| Request | - | Major Site Plan Review for New Parking Lot |
| Location | - | 3301 Central Avenue |

MAJOR SITE PLAN REVIEW
TOLEDO CITY PLAN COMMISSION
REF: SPR25-0029
DATE: August 14, 2025
TIME: 2:00 P.M.

ENLARGED SITE PLAN

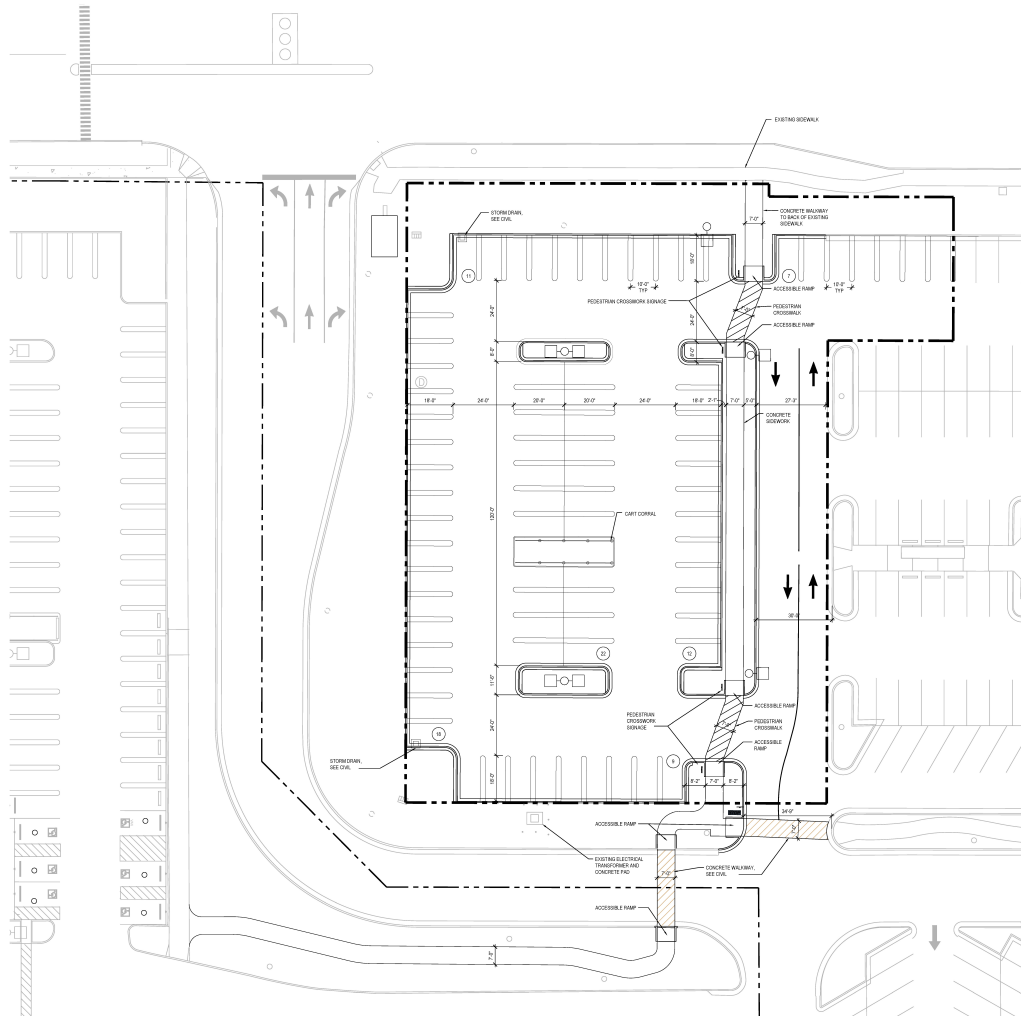
2. The cross walk crossing main drive lanes needs to be moved East to other side of the stop line. Consideration should be given to making that a raised crosswalk for pedestrian safety.

16. A raised crosswalk shall be installed across the drive labeled "Markway Road" – otherwise known as the site's main drive access to Central Avenue – between the proposed additional parking the existing Costco store. **Not acceptable as depicted on site plan. Crosswalk details shall be submitted to the Plan Director and Division of Traffic Management for review and approval.**
17. An additional crosswalk shall be installed across the north-south drive aisle between the proposed additional parking and the existing pedestrian walkway leading to the site. **Not acceptable as depicted on site plan. A revised site plan shall be submitted to the Plan Director depicting this additional crosswalk.**

18. A minimum of sixteen (16) bicycle parking spaces shall be installed on the site. Bicycle parking spaces may be located on the additional parking property, the existing Costco property, or both. **Not acceptable as depicted on site plan. A revised site plan shall be submitted to the Plan Director depicting a minimum of sixteen (16) bicycle parking spaces.**

LANDSCAPE PLAN

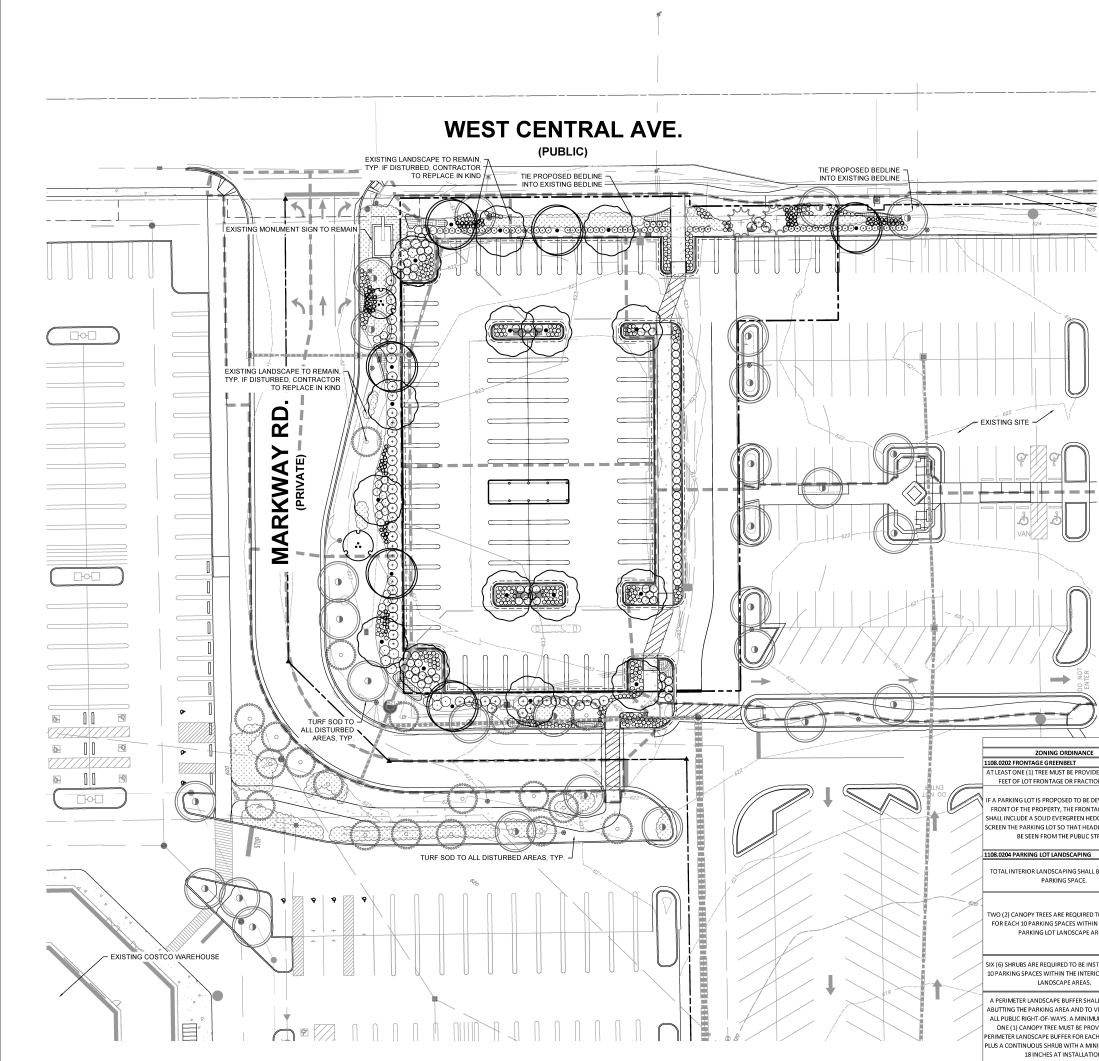
19. Topsoil must be back filled to provide positive drainage of the landscape area.
20. Landscaped areas may not contain bare soil, aggregated stone or decorative rock. Any ground area must be covered with hardwood mulch, grass or other vegetative ground coverage.

21. Water outlets (hose bibbs) shall be provided within 100 feet of all required plant material unless a subsurface irrigation system is used. If a subsurface irrigation system is used, irrigation plans must be submitted with development plans and must contain all construction details.

22. The location, number, height, diameter and species of any materials to be planted and maintained shall be depicted on a detailed 'final' landscape plan, as well as the location and number of any existing trees to be retained. Trees, shrubs, and landscape materials shall meet the standards included in TMC§ 1108.0400 *Landscape Materials Standards*.
